RE: Application MP 10_0006. Pindimar Abalone Project.

As a permanent resident I object to the Pindimar Abalone Project for the following reasons:-

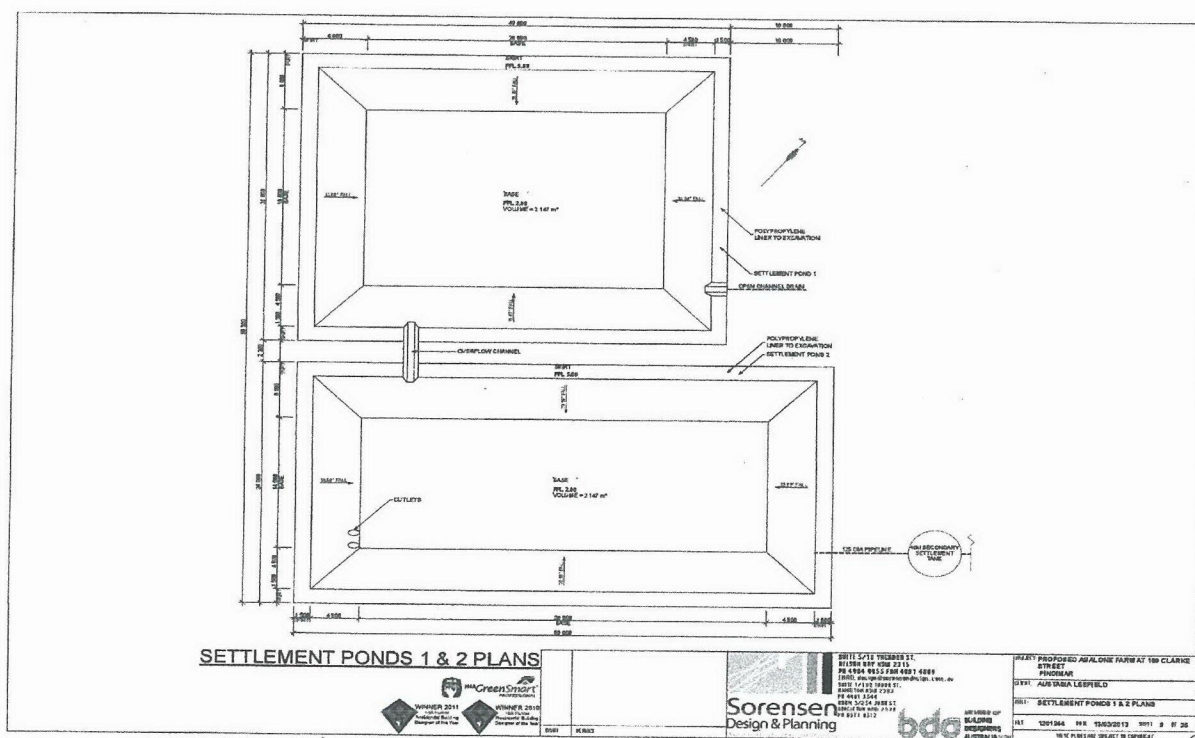
3. Settlement Pond #2. The design for Settlement Pond #2 is not conducive to settlement and detracts from the purpose of the Marine Water Quality Management System.

- Refer to attached Settlement Ponds 1 & 2 Plan from Appendix 2 of the EAR.
- Pond 1 is a relatively standard design with solids settling out in the pond as the velocity slows, this pond then overflows to Pond #2 via a high level overflow channel.
- Pond 2 has inlets from Pond #1 and Settlement Tank #2. Dual outlets with a capacity of around 580l/s at the bottom or invert of the pond mean it's unlikely to operate as a standard settlement pond as what comes in will go straight out with no detention.
- There is no clear explanation or methodology shown as to how Settlement Pond #1 will be by-passed for periodic cleaning or how flow will be diverted to Pond #2.

- Figure 17 Marine water Quality Management System –Conceptual View attached

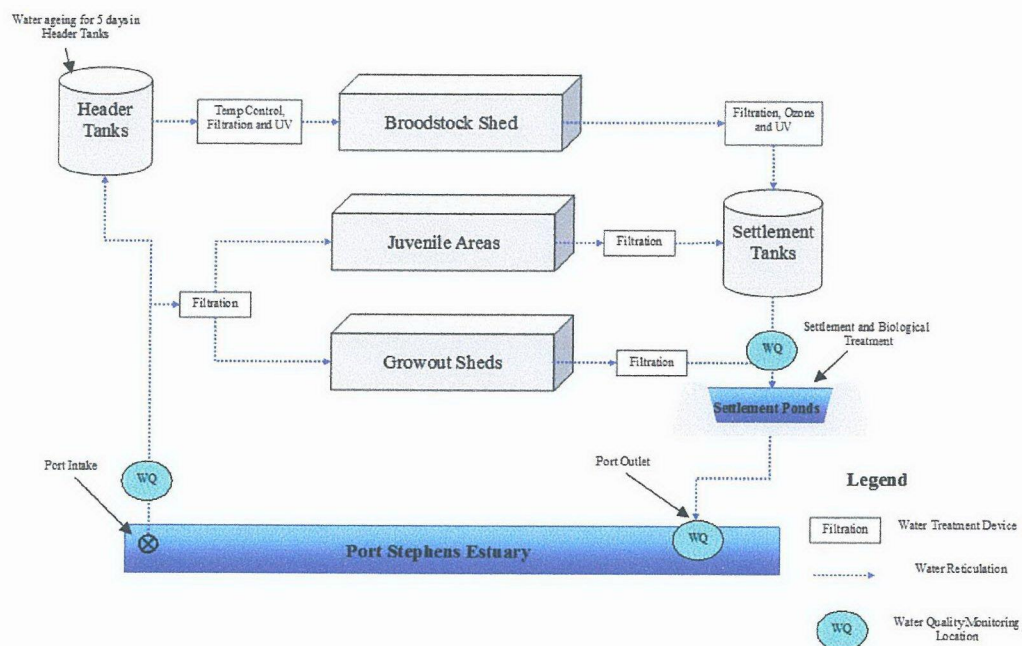
- In reference to the Pindimar Abalone Farm Environmental Assessment Report page 125 and Marine water Quality Management System –Conceptual View attached:

- The configuration of Settlement Pond #2 as currently shown indicates that discharge water from the Broodstock and Juvenile Areas via the Settlement Tanks will not undergo Settlement Pond residence time.
